**SOLICITATION AMENDMENT
MODIFICATION DE L'INVITATION**

Title - Sujet BIO Secondary Access Road Construct	
Solicitation No. - N° de l'invitation EB144-180972/A	Amendment No. - N° modif. 003
Client Reference No. - N° de référence du client EB144-18-0972	Date 2017-09-19
GETS Reference No. - N° de référence de SEAG PW-\$PWA-122-5643	
File No. - N° de dossier PWA-7-78059 (122)	CCC No./N° CCC - FMS No./N° VME
Solicitation Closes - L'invitation prend fin at - à 02:00 PM on - le 2017-09-26	Time Zone Fuseau horaire Atlantic Daylight Saving Time ADT
F.O.B. - F.A.B.	
Plant-Usine: <input type="checkbox"/> Destination: <input checked="" type="checkbox"/> Other-Autre: <input type="checkbox"/>	
Address Enquiries to: - Adresser toutes questions à: Chinye (PWA), Chukwudi	Buyer Id - Id de l'acheteur pwa122
Telephone No. - N° de téléphone (902) 496-5476 ()	FAX No. - N° de FAX (902) 496-5016
Destination - of Goods, Services, and Construction: Destination - des biens, services et construction:

La modification 003 vise à apporter les changements suivants à l'annexe 1-Combined sous forme de prix, et pour répondre aux questions posées. La présente modification vise aussi à intégrer les changements à la

ASPHALT STRUCTURE PARKING LOT

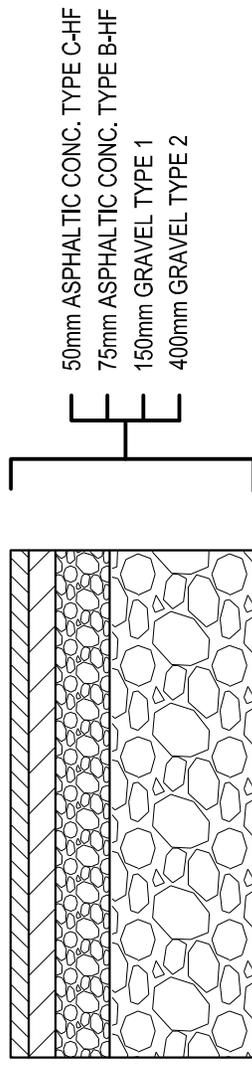
Question 10: Provide details on the asphalt and gravel structure for the parking expansion as shown on DWG C21. How will we be getting paid for this work?

Answer to Question 10: Pavement structure detail provided. Quantities will be paid under existing gravel and asphalt paving unit price items. Refer to Addendum revision to Drawing C23 for detail, as well as Specification Section 01 29 00 – Measurement and Payment.

- .1 ADD 'Detail 11 – Asphalt Structure Parking Lot' on CSK-08 (attached).

HALIFAX
 REGIONAL MUNICIPALITY

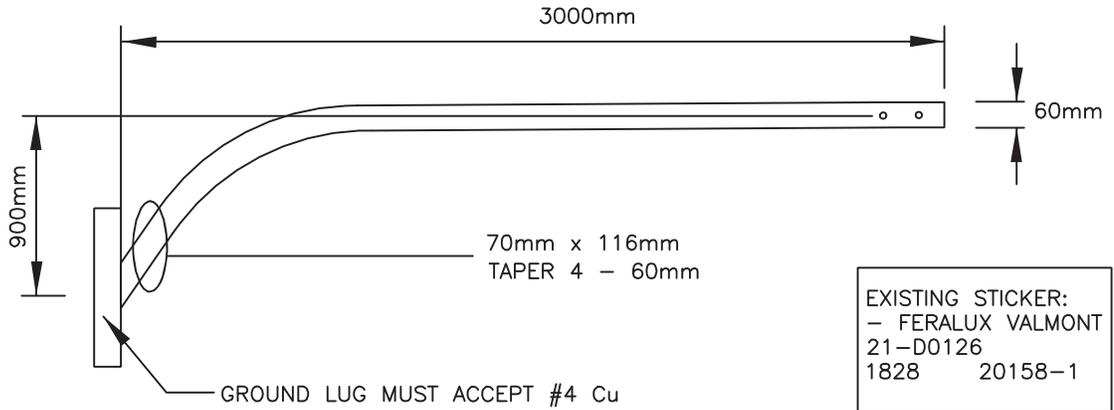
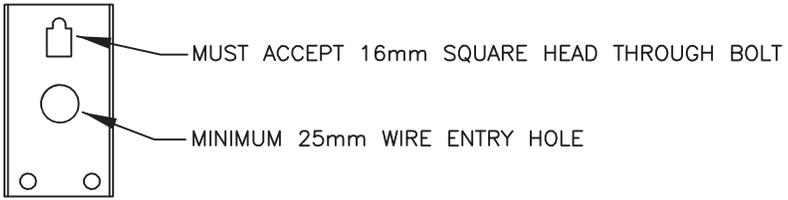
Question 18: Drawing E2 – Note 2 – Light fixtures according to hrm standard – Could you clarify the desired davit arm length for the light fixture?

Davit arm details clarified. Refer to Addendum revision to Drawing E2 and Specification Appendix A.

“2. Davit arm to be in accordance with Halifax Standard Drawing HRM 101.”
